# ADDENDUM

Project: Revised Craft State Office Building - Chiller Replacement.

Project No.: 11115

Addendum No.: 1

#### A. Electrical One-Line Diagram

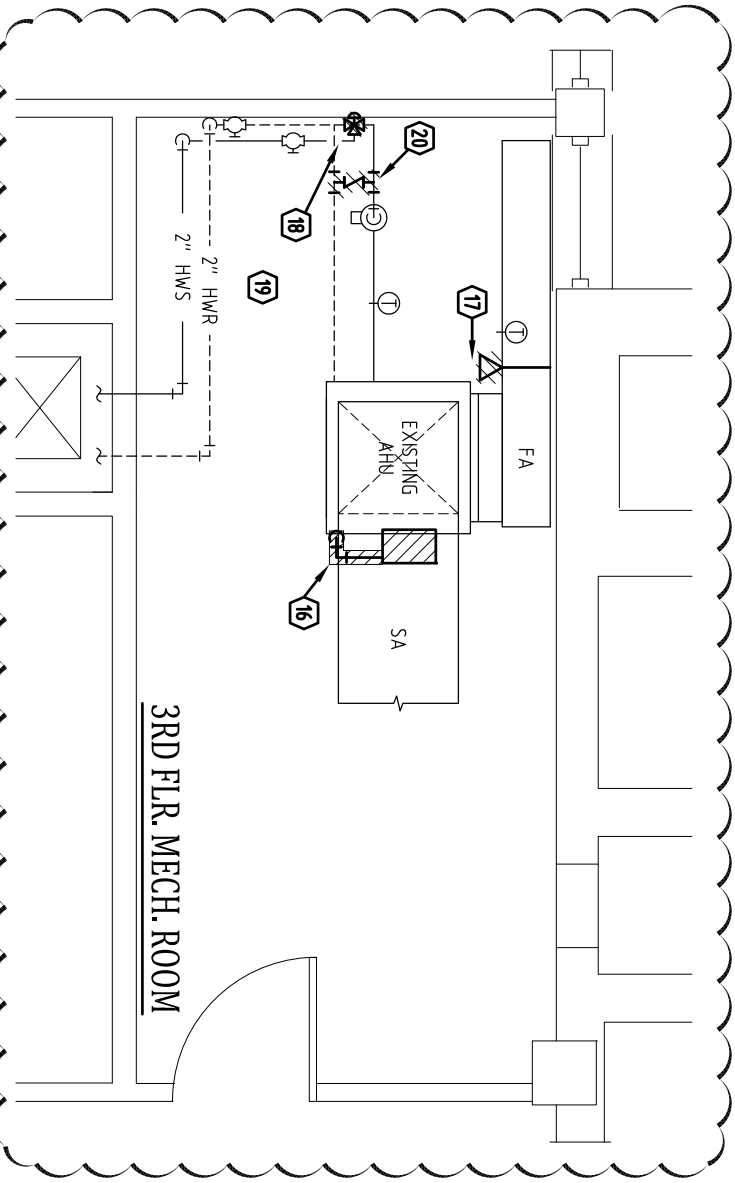
- 1) Provide (3) spare 1200A. fuses for the Main Service Disconnect (MSD). Fuses for this application shall be Class L, fast acting.

**3RD FLOOR MECHANICAL ROOM - PHASE 1 & PHASE 2**

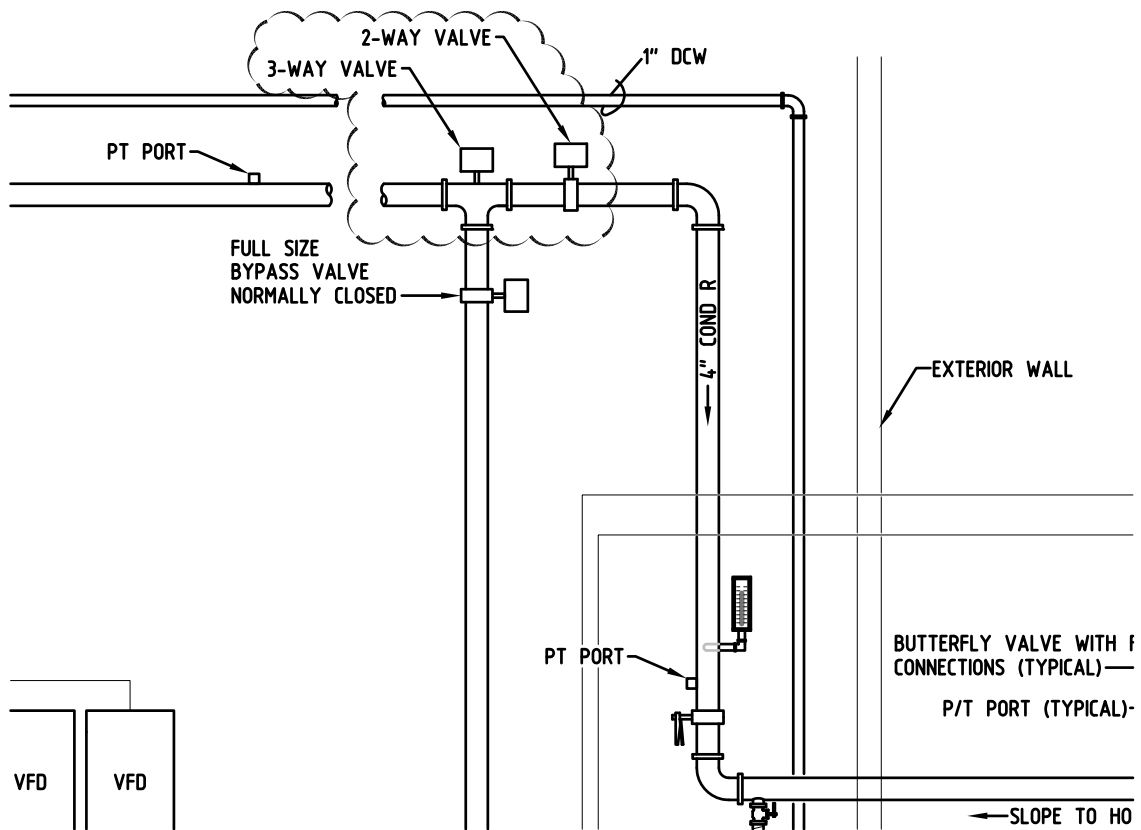
##### **A. 3<sup>RD</sup> Floor Mechanical Room – Phase 1 and Phase 2**

- 1) Add note 19, it shall read “Re-insulate all hot water piping in the 3<sup>rd</sup> floor mechanical room per the schedule.” Note 19 shall point to the existing piping to the existing MAU.
- 2) Add note 20, it shall read “Remove existing bypass and check valve, install new bypass with new check valve and gate valve.”
- 3) See revised floor plan drawing attached.

## CHILLED WATER SYSTEM DETAIL

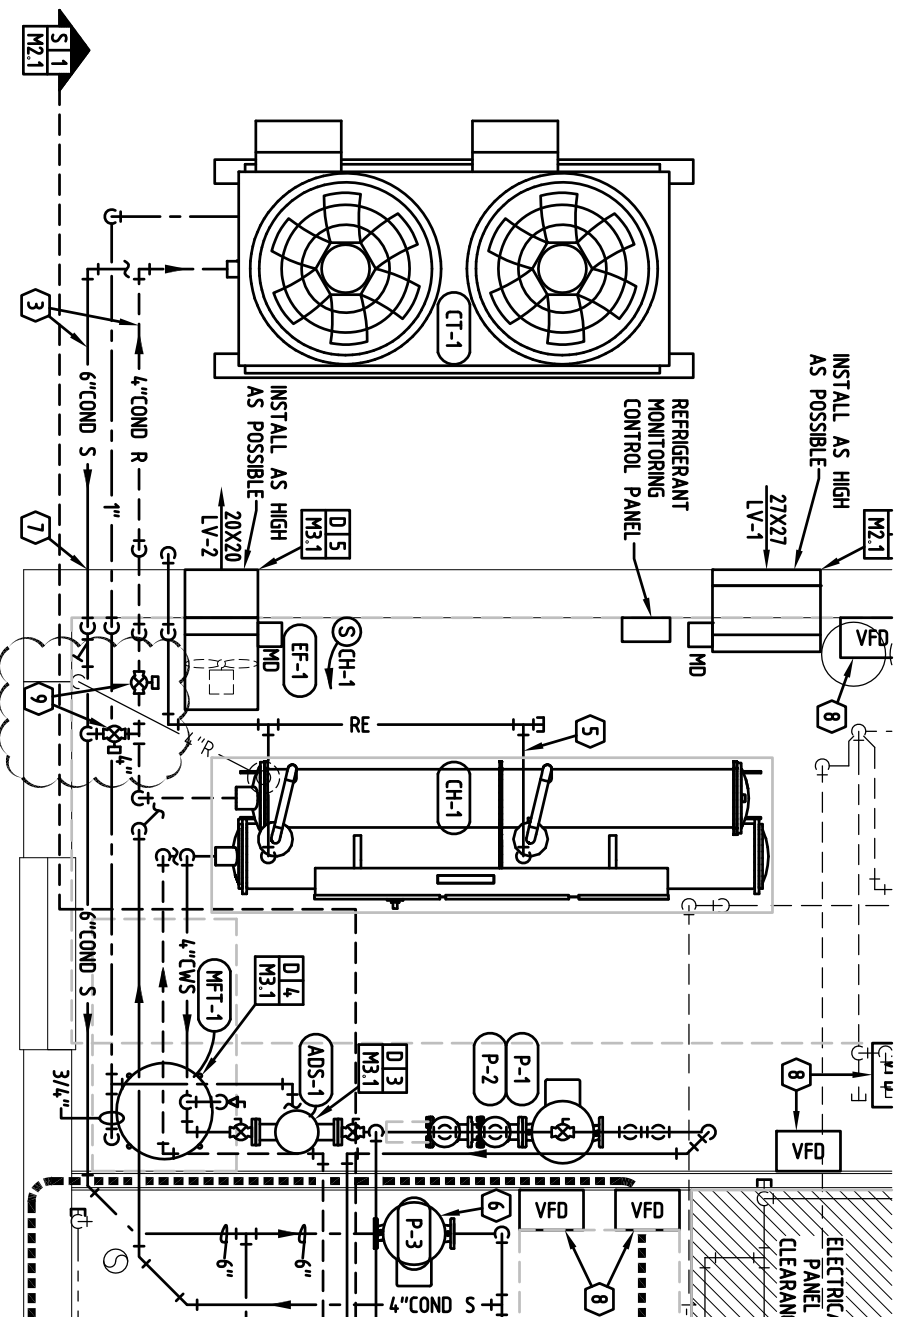
##### **B. Chilled Water System Detail**

- 4) The cooling tower bypass valve shall be a 3-way valve or (2) 2-way valves.
- 5) Mechanical contractor to install water meter (provided by chemical contractor) in make-up feed line to cooling tower inside and all other valving/ports (provided by chemical contractor) required.
